CERN FCC – COST & SCHEDULE UPDATE

8 SHAFT SCHEME

WORKSHOP / 08.08.2023

OPTIMIZATION DISCUSSION - WORK SHOP

Point F

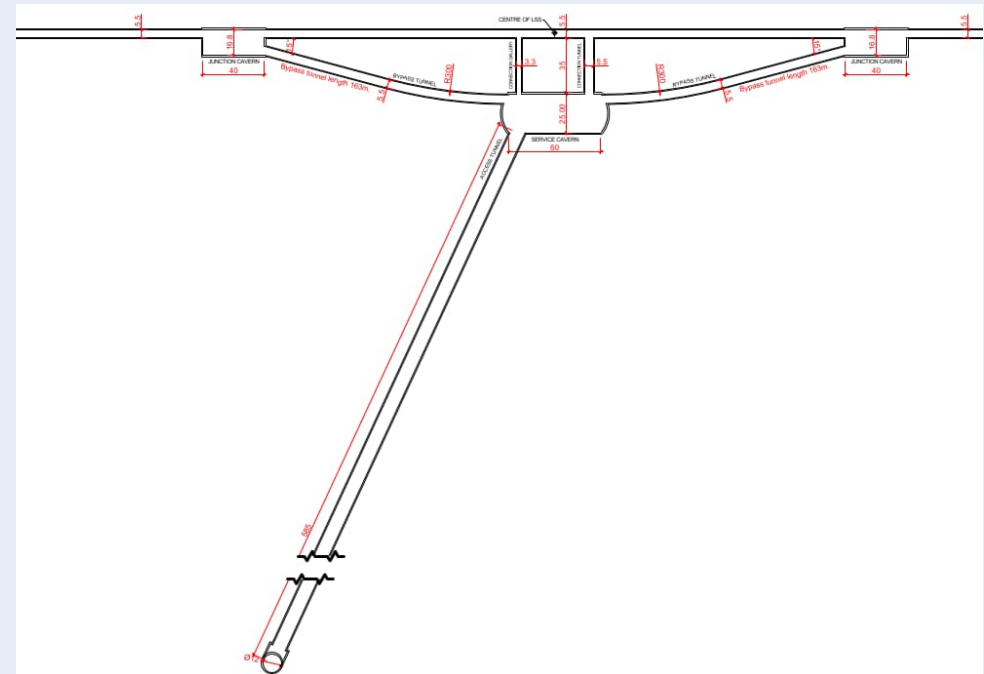
- What slope of access tunnel might be suitable?
10 % would reduce shaft depth by approx. 60 m
15% would reduce shaft depth by approx. 90 m
(15% increases tunnel drive costs)
- In the CDR-study we made some comparisons between 10 and 15%.
- Schedule reduction at this location negligible
- Cost reduction approx. 1.5 Mio. EUR

Point H and L - Klystrons

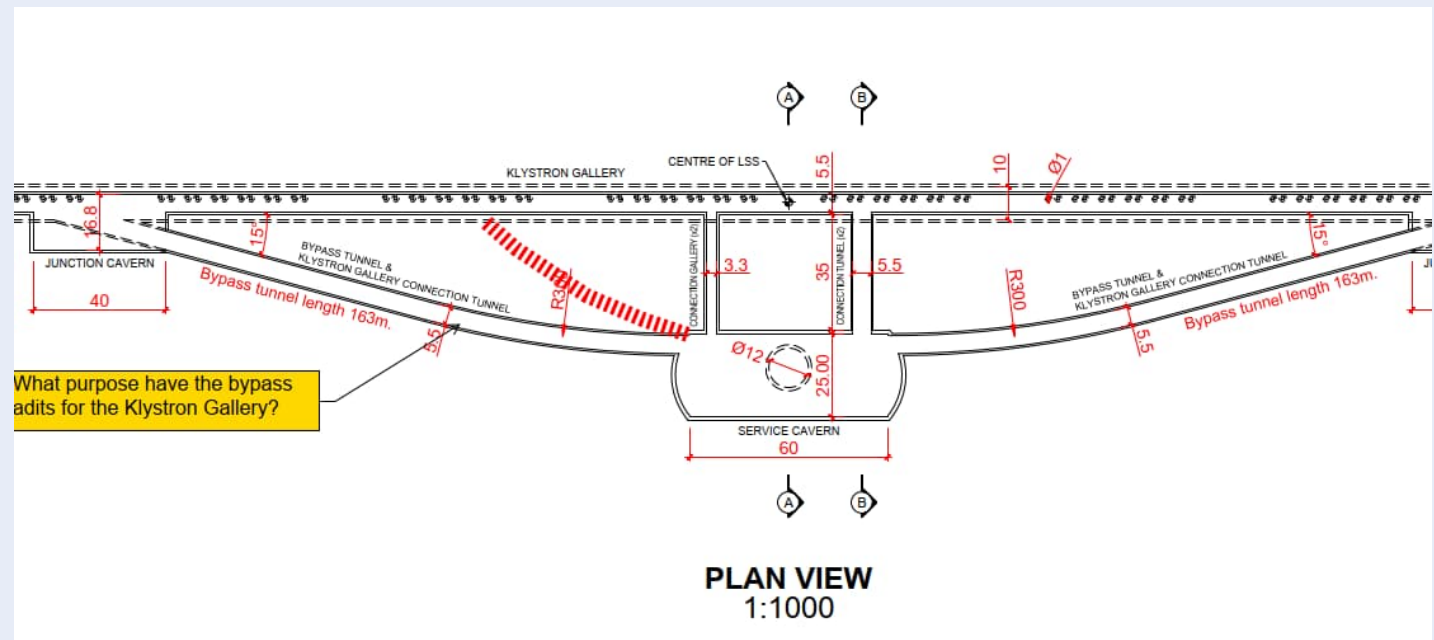
- What purpose have the bypass adits for the Klystron Gallery?
- may they be shortened as indicated (if just for Construction purposes, they might be omitted).
-

Shaft Diameters

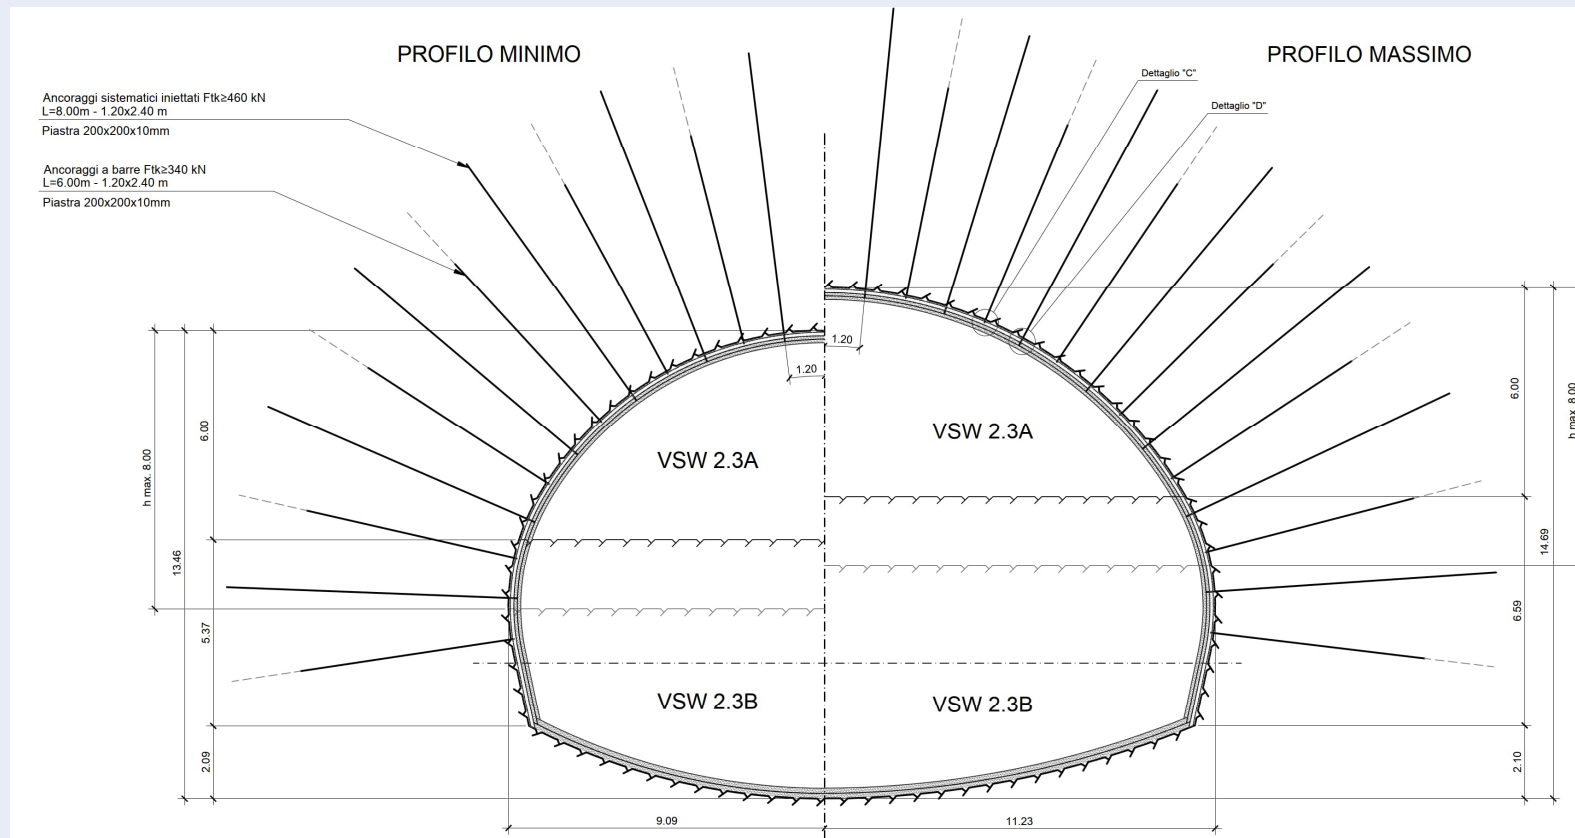
At the moment most advance faces are planned sequential therefore the shaft dia. may be sufficient, in case of acceleration of schedule following shafts might require larger diameter.

- Point B – 1 TBM advance
shaft dia. 12 m is okay
 - Point L - 1 TBM plus Klystron drives
shaft dia. 12 m ok for sequential advance
- if parallel drives dia. has to be enlarged (15 m)

Single lining – Ceneri Base Tunnel, Crossover caverns

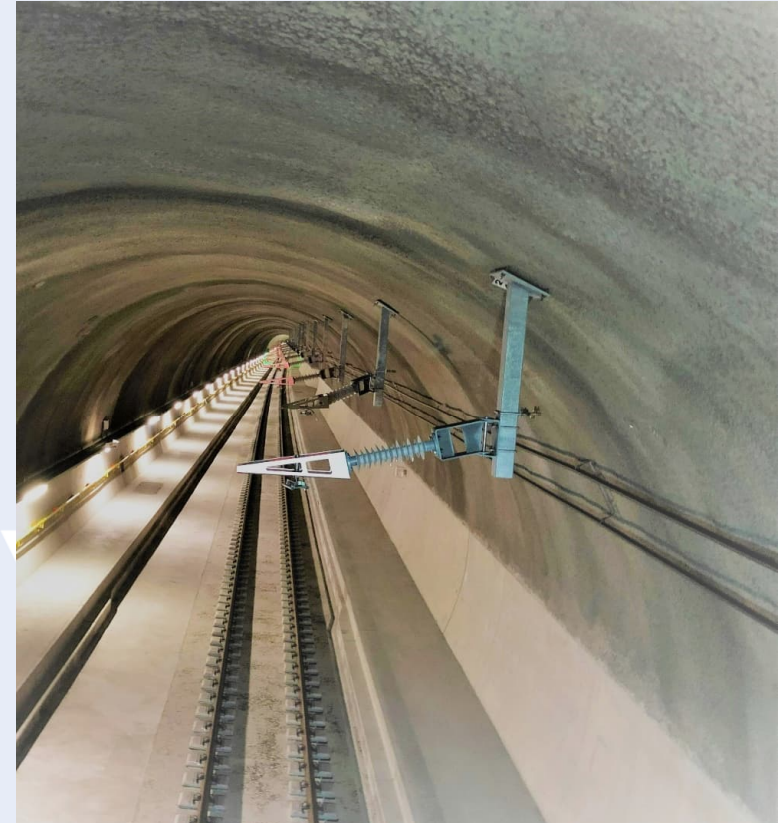
- Cavern span up to 22 m
- Lower part insitu cast concrete with shutter, upper part shotcrete
